## GOVERNMENT OF INDIA NORTH EASTERN COUNCIL SECRETARIAT NONGRIM HILLS, SHILLONG - 793003

ect. Forwarding of Inspection Report.

## Report of the inspection carried out on 20/02/2018 for the NEC funded project "Construction of Outdoor Stadium at Tezu, Lohit District, Arunachal Pradesh".

MS Gate

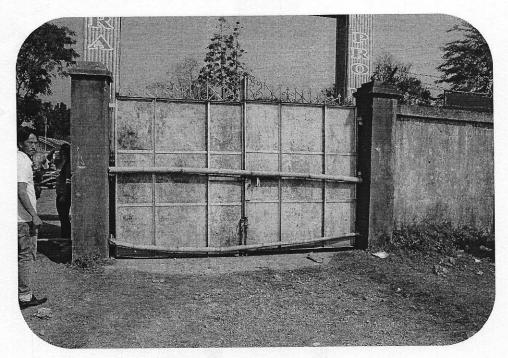
- As for the gate and pillar, the Implementing department informed that the work had been completed since march 2015. It was observed that the painting in the gate and in the pillars has worn out. Therefore the implementing department was instructed to repaint the gate and the pillars before submitting the completion report and photos should be send to NEC.
